MISSISSIPPI POWER & LIGHT COMPANY

SUBJECT: Grand Gulf Nuclear Station
Units 1 and 2
Docket Nos. 50-416 and
50-417
License No. NPF-13
File: 0260/L-860.0/L-952.0/
M-189.0
Inservice Inspection to
ASME Section XI (Request
Nos. I-00001 through
I-00011)
AECM-84/0335

INSERVICE INSPECTION RELIEF REQUESTS
FOR GRAND GULF NUCLEAR STATION
(I-00001 THROUGH I-00011)

VERTICAL SECTION THRU GUARD PIPE ASSEMBLY
 GRAND GULF NUCLEAR STATION
 UNIT 1

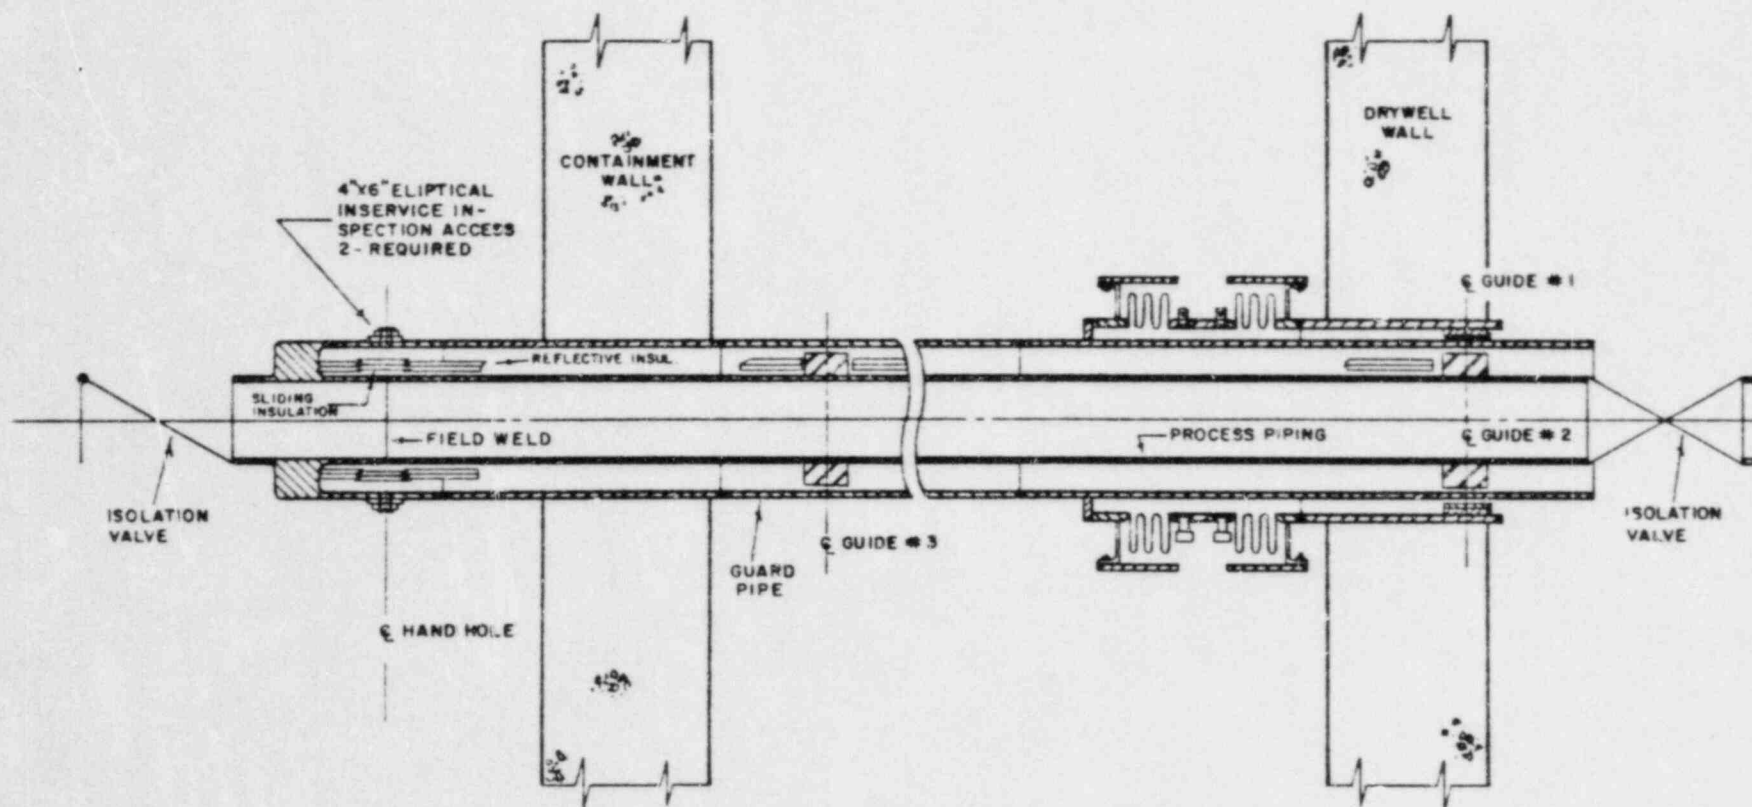
- I. Component: Internal process pipe supports (guides #2 and #3) are inaccessible for inservice inspection because they are located inside guard pipes. The affected internal supports and their associated piping systems are as follows:

- IV. Information to support the determination that the code requirement is impractical: The component supports were provided for the guard pipes as required by stress analysis to act as restraints which limit lateral movement and as dead weight supports for the process pipe within the guard pipe. These inaccessible supports are located inside guard pipes that extend from the drywell wall through the containment building to the auxiliary building. During installation of the process pipe and guard pipe assembly between drywell wall and the first outboard isolation valve, the supports were accessible for examination because of the installation sequence used. After guard pipe components were assembled and welded in place, the access to the supports was no longer available.

- V. Specific relief requested: Permission is requested to delete all visual examinations for the supports identified.
- VI. Reason why relief should be granted: Exemption is requested for inservice visual examination of these component supports for the following reasons:

1. The supports are inaccessible because they are located in guard pipes which are filled with reflective insulation that cannot be removed.
 2. These supports were visually inspected in accordance with ASME Section III, Subsection NF.

3. These supports were preservice examined in accordance with ASME Section XI.
 4. These supports serve as pipe guides to restrict lateral movement of the pipe to which they are attached. In addition, these supports also serve as dead weight support for the process pipe. Additional restraints are provided outside the no-break zone as required by pipe break analysis. The failure of any of these inaccessible supports would not damage the pressure boundary of the process pipe or affect the integrity of the guard pipe.

DETAIL of 91

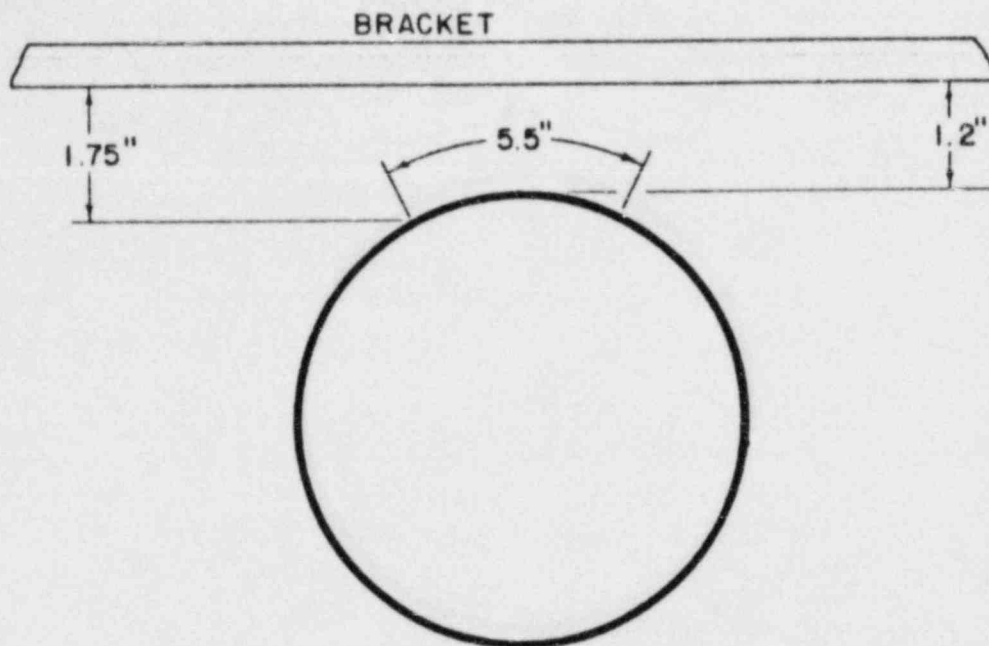
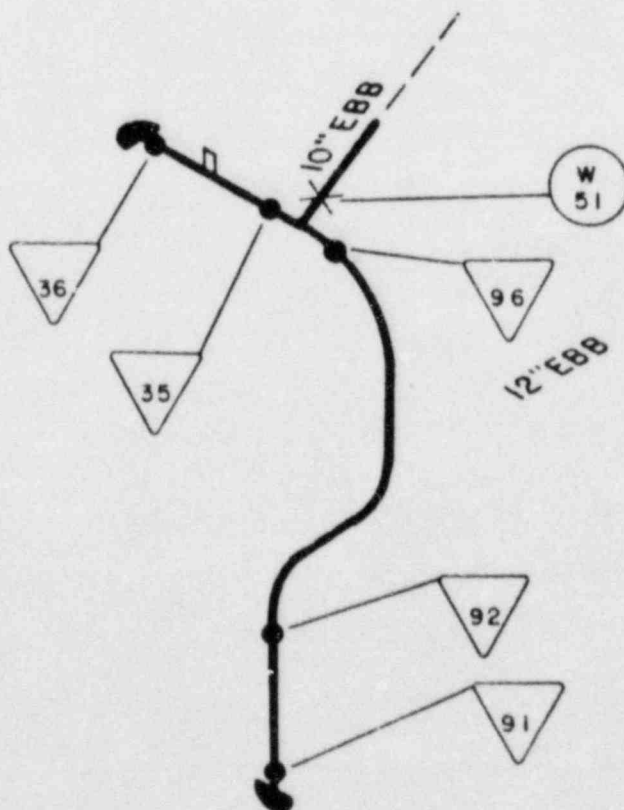
- I. Component: An inaccessible portion of weld No. 91 on the scram discharge volume piping (12" EBB line) is located in the Control Rod Drive Hydraulic (C11) System. (See the attached sketch)

- IV. Information to support the determination that the code requirement is impractical: The installation of a bracket directly above the circumferential weld No. 91 has limited the accessibility to the weld for ultrasonic examination. The inaccessible portion of the weld is approximately 5.5 inches of the circumference of the 12 inch NPS pipe, or 14 percent of the weld length.

- V. Specific relief requested: Permission is requested to obtain a relief from the requirement to volumetrically examine the portion of weld No. 91 inaccessible due to the installed bracket.

5.5" INACCESSIBLE DUE TO BRACKET

The accessible portion of the weld will be volumetrically and surface examined each inspection interval in accordance with ASME Section XI, Table IWC 2500-1. Portion of the weld which cannot be volumetrically examined would be surface examined in accordance with ASME Section XI, Table IWC 2500-1, Category C-F requirements. Should indications be found, an engineering evaluation will be made to determine if the inaccessible portion of the weld has been affected. The inaccessible portion of this weld represents approximately 14 percent of the total weld length.

NO. 1B2 GIRTH SEAM

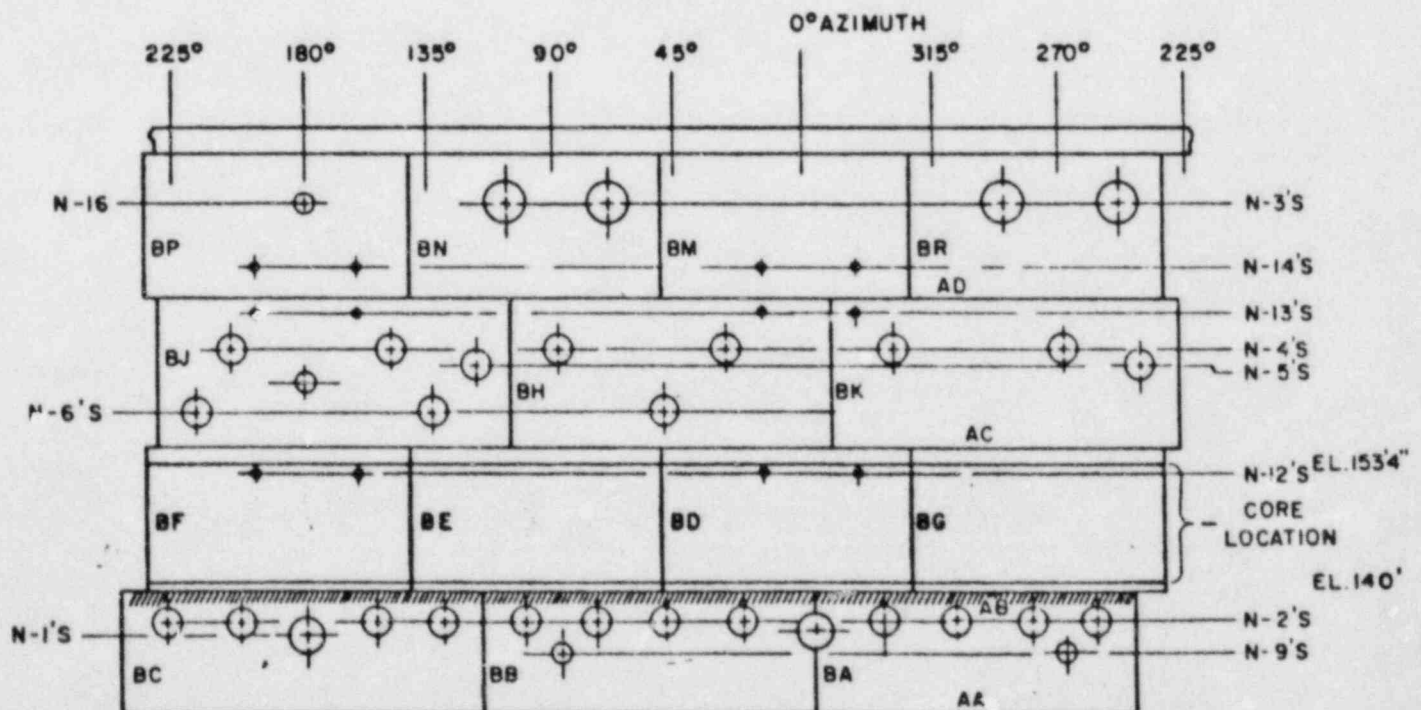
- I. Component: The lower half of seam weld AB of the Unit 1 reactor pressure vessel (See Sketch #1).
- II. Code: The Unit 1 reactor pressure vessel was designed and fabricated to ASME Section III, Class 1 requirements. Applicable inservice inspections are to be performed in accordance with the ASME Section XI, 1977 Edition with addenda through and including Summer 1979 Addenda.

- However, due to the nozzle interference with the automated ultrasonic equipment and the irregular geometry on the lower portion of weld AB, remote examination is not possible. Therefore, this portion of the weld must be examined by the manual procedure.

- V. Specific relief requested: Permission is requested to delete all ultrasonic inservice inspection on the lower one-half (Category B-A Item B1.11 requirements) of the entire circumference of the AB weld, except as noted under alternate examinations.

Instead of examining the entire lower one-half of the AB weld, we propose to perform manual ultrasonic examinations only on the section of the weld in which the four recordable indications were found (approximately a 13 inch by 22 inch surface area), once per inservice inspection interval. We will monitor the sizes of the indications and, if any of the indications appear to be increasing in size, we will evaluate the indications and take appropriate action, which may include ultrasonic examinations of other sections of the weld. The anticipated exposure for performing these alternative examinations would be less than 4600 mrem.

NO. 2 & 3 RINGS TOGETHER
GIRTH SEAM

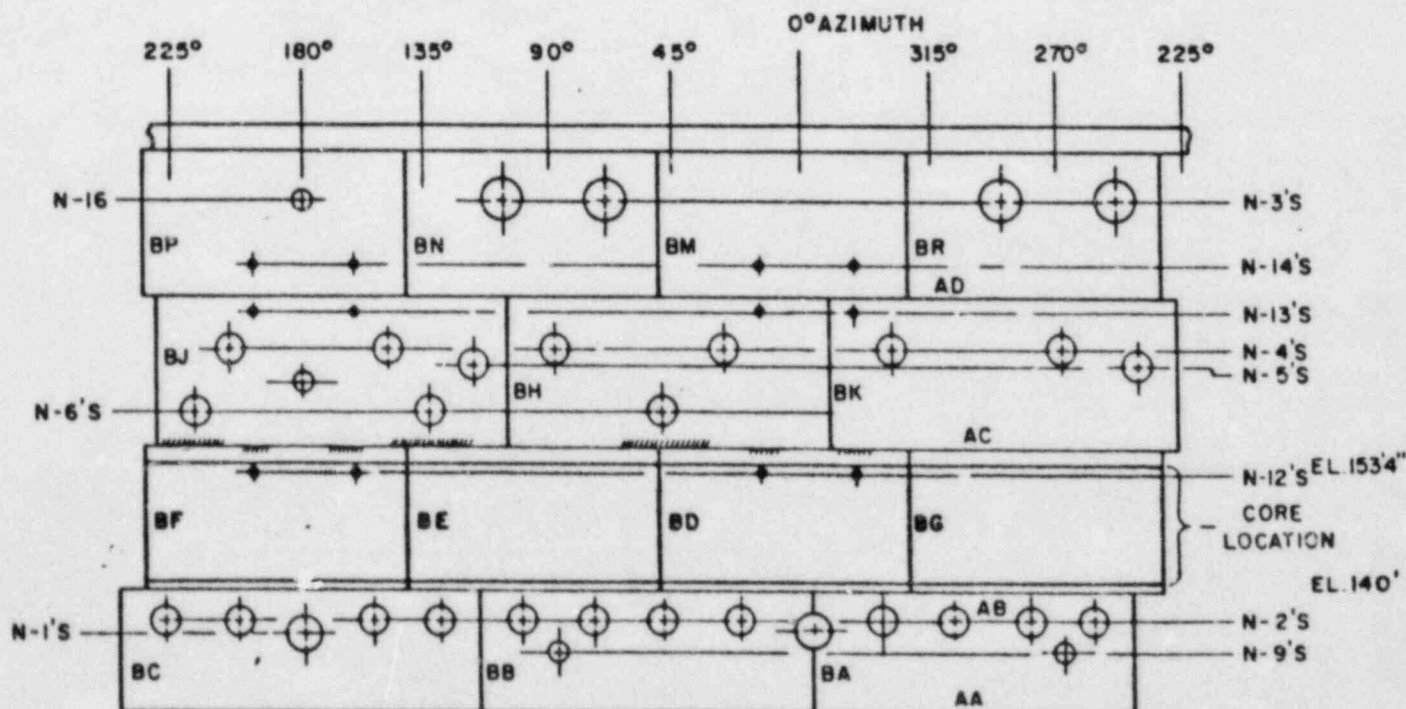
I. Component: Section of seam weld AC of Unit 1 reactor pressure vessel.
(See Sketch #1).

Except for areas around the N6 nozzles and the N12 nozzles, seam AC was examined with the automated ultrasonic equipment. Approximately 23 inches on each side of each N6 nozzle's centerline and 18 inches on each side of each N12 nozzle's centerline required manual ultrasonic inspection. The nozzles are located so close to the seam that they interfere with the automated equipment.

- V. Specific relief requested: Permission is requested to delete all manual ultrasonic inservice inspection on the areas of weld AC affected by the presence of intruding N6 and N12 nozzles. This length consists of approximately 23.5 ft out of total 138 ft circumference of the AC weld on both sides (approximately 69 ft for one side). Therefore, approximately 83 percent of the required examinations are performed by the remote method.

- VII. Alternate examinations: Since weld AC did not have any recordable indications by manual examination, no alternate examinations are planned for this seam.

VERTICAL SECTION THRU GUARD PIPE ASSEMBLY

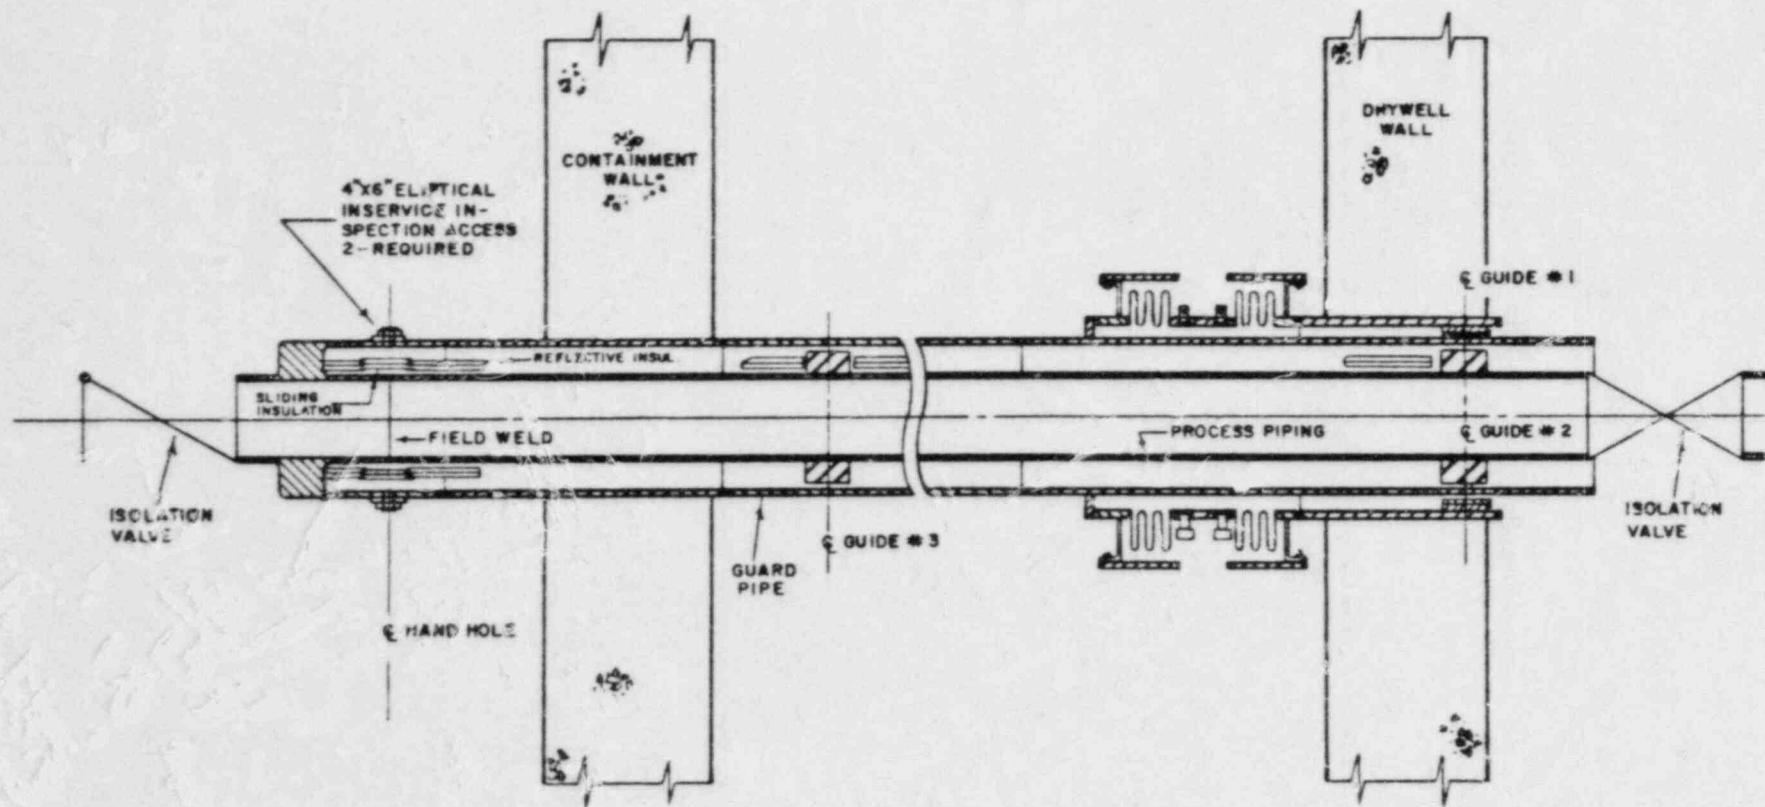
- I. Component: ASME Section III Class 1 pressure retaining circumferential welds located in Feedwater Loops A and B (B21), Main Steam (B21), Main Steam Drain (B21), Reactor Core Isolation Cooling (E51), Residual Heat Removal (E12) and Reactor Water Clean-up (G33) piping. These welds are located on system piping inside guard pipes, which extend beyond the containment. The applicable welds are listed on Table 1.

- IV. Information to support the determination that the code requirement is impractical: The circumferential welds joining the flued head and the process pipe are encapsuled by the portion of the guard pipe which protrudes beyond the containment. To comply with the inservice inspection requirements of ASME Section XI, two 4 x 6 inch elliptical access ports spaced 180 degree apart are provided for access to the welds. During the development of the access port design, the inservice contractor had indicated that the ports were adequate to permit performance of ultrasonic examination of the entire weld. After fabrication and installation of the process pipe, guard pipe and the flued head, it was determined that the entire length of the weld is not accessible through the two access ports. Approximately 50% of the weld is accessible for inservice inspection.

- V. Specific relief requested: Permission is requested to permit only ultrasonic examination of the accessible areas of the weld, except as noted under alternate examination.

The accessible length of each weld will be ultrasonically examined in accordance with ASME Section XI, Table IWB-2500-1, Examination Category B-J. Should signs of weld deterioration or discrepancies be noted during regular inspections, evaluation of the conditions will be made.

GRAND GULF NUCLEAR STATION
UNIT 1
INSERVICE INSPECTION
REQUEST FOR RELIEF NO. I-00011

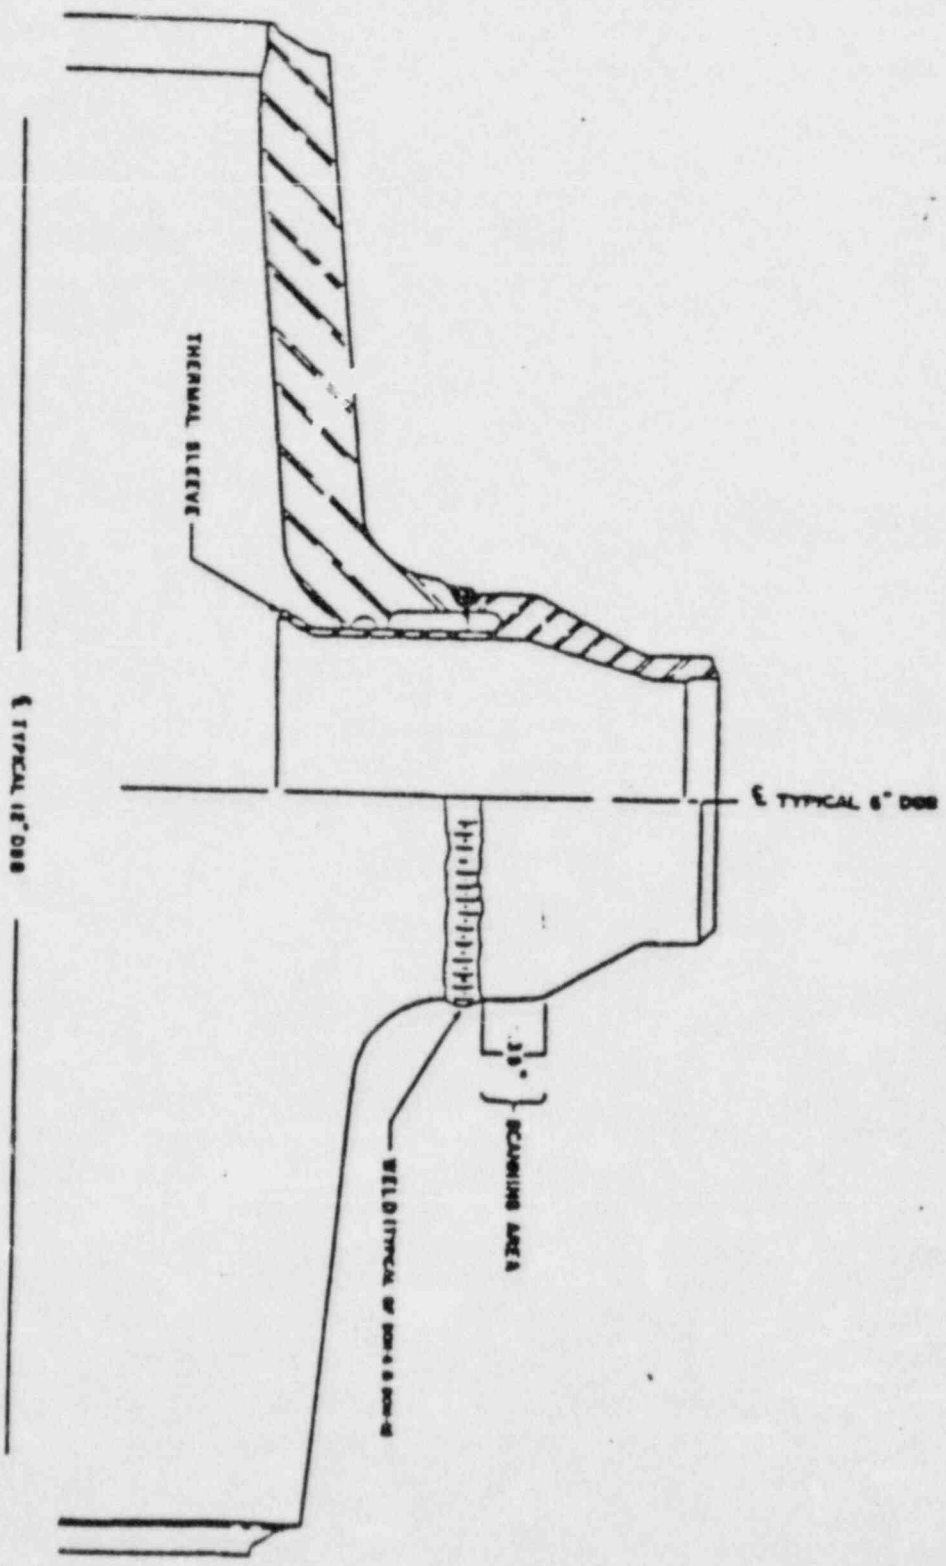
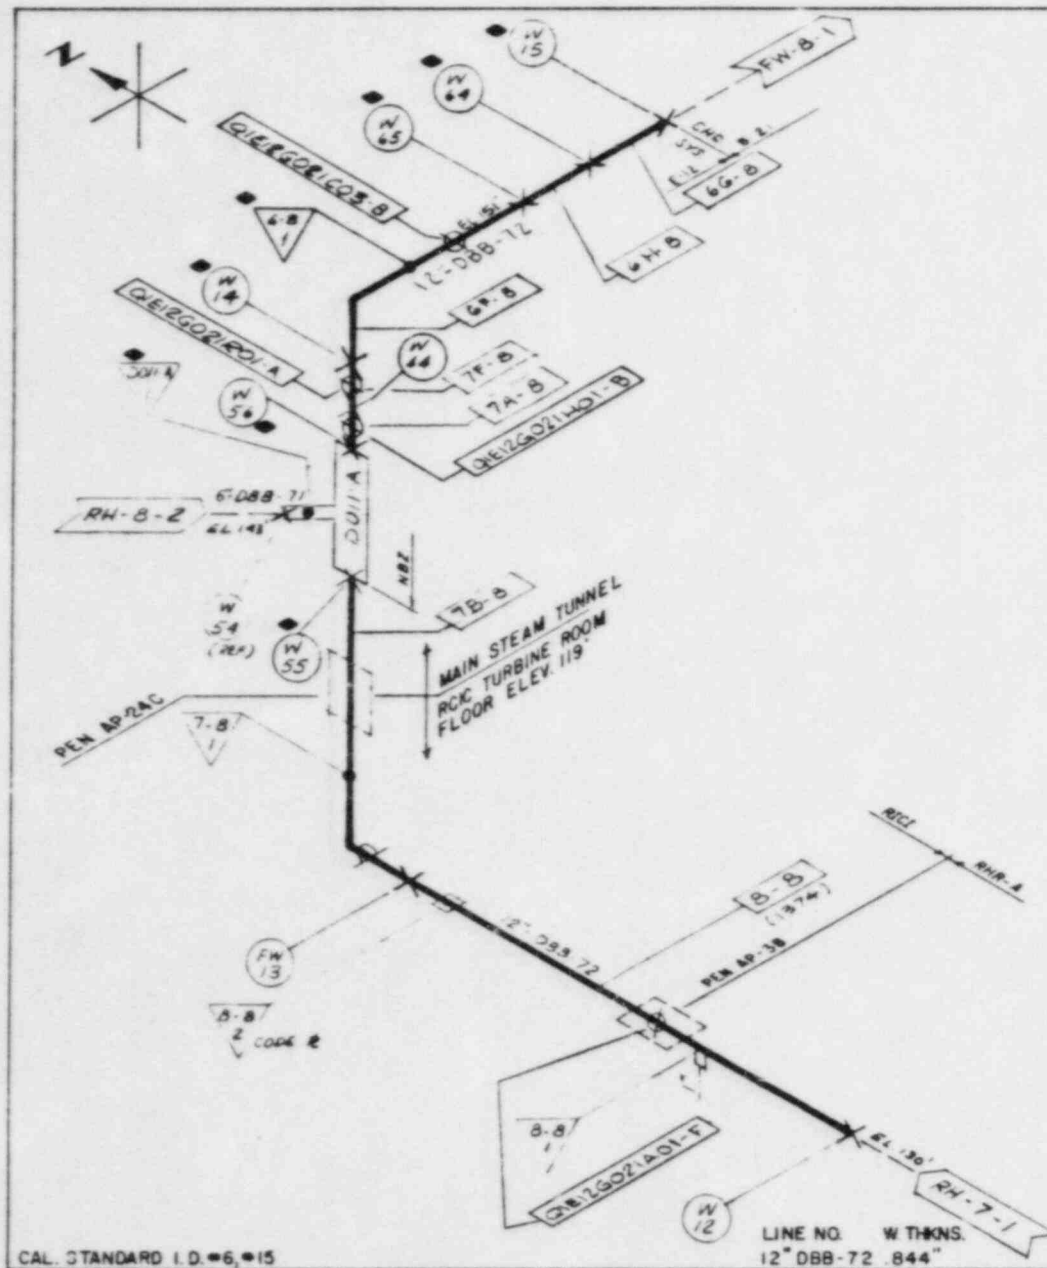
5. Leak detection is provided for the main steam tunnel, via the leak detection system in the control room which would detect a leak in the thermal tee sleeve weld.
6. The system design would allow for isolation of the thermal sleeve without adversely affecting plant safety.

Our inservice inspection plan requires that the thermal tee sleeve weld be examined twice during the ten-year interval by the magnetic particle technique.
